ADDRESS: 5416-26 LENA ST

Proposal: Convert three-story garage building for residential use

Review Requested: Final Approval

Staff Contact: Alex Till, alexander.till@phila.gov

ELEVATION-RENDERING

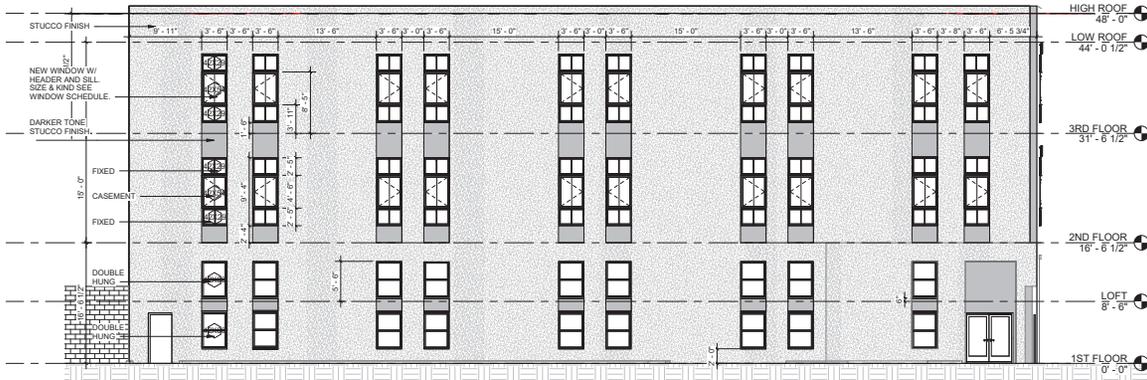
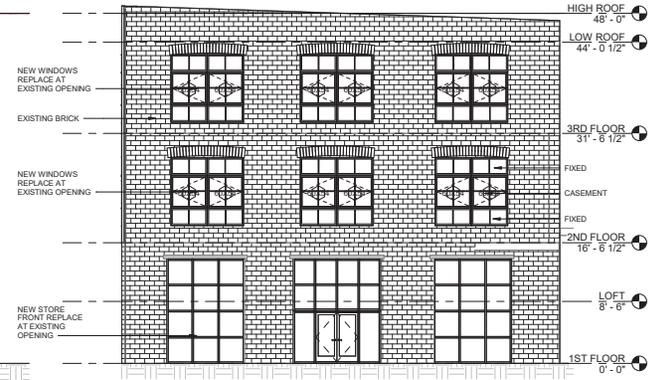
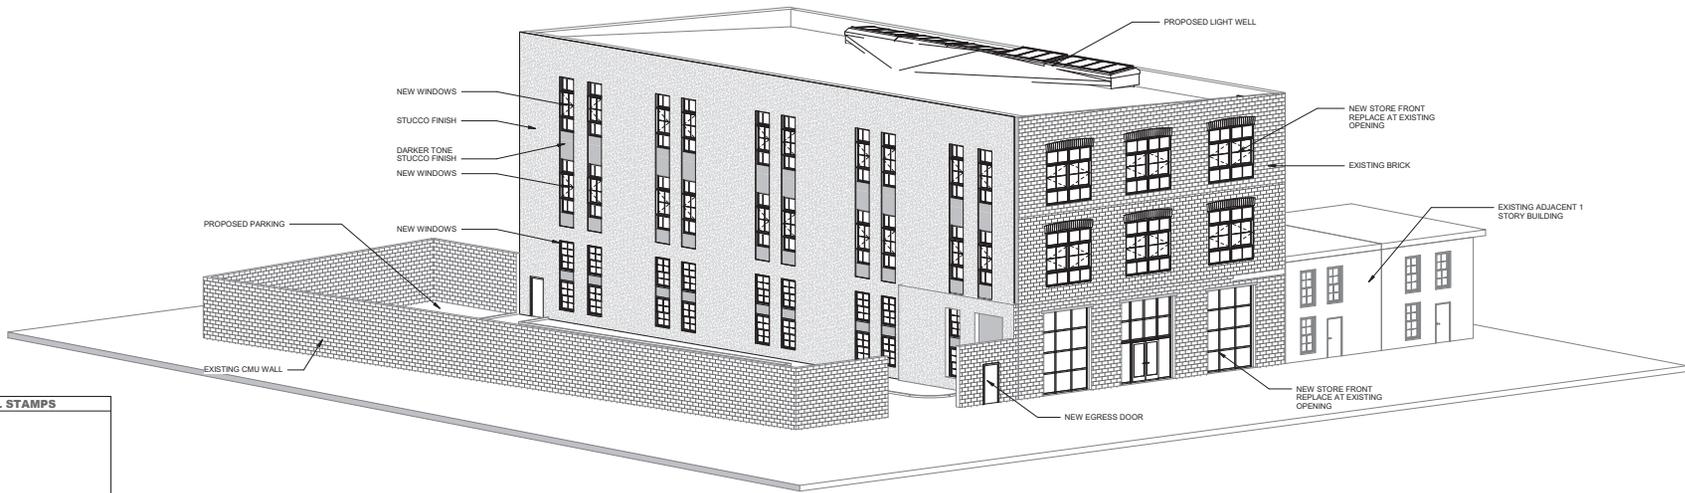
- *Standard 9: New additions, exterior alterations, or related new construction shall not destroy historic materials that characterize the property. The new work shall be differentiated from the old and shall be compatible with the massing, size, scale, and architectural features to protect the historic integrity of the property and its environment.*
 - The proposed new windows, storefronts, window openings, and lightwell satisfy Standard 9 provided that the materials used are compatible. They will be differentiated from old features and are compatible with the massing, size, scale and architectural features of the property.
 - The proposed new stucco will satisfy Standard 9 provided that it is toned down to better blend with the historic character of the building.

STAFF RECOMMENDATION: Approval, provided that the new windows and storefronts are made with compatible materials and the new stucco is revised to a darker color that is more compatible with the historic materials of the building, with the staff to review details, pursuant to Standard 9.
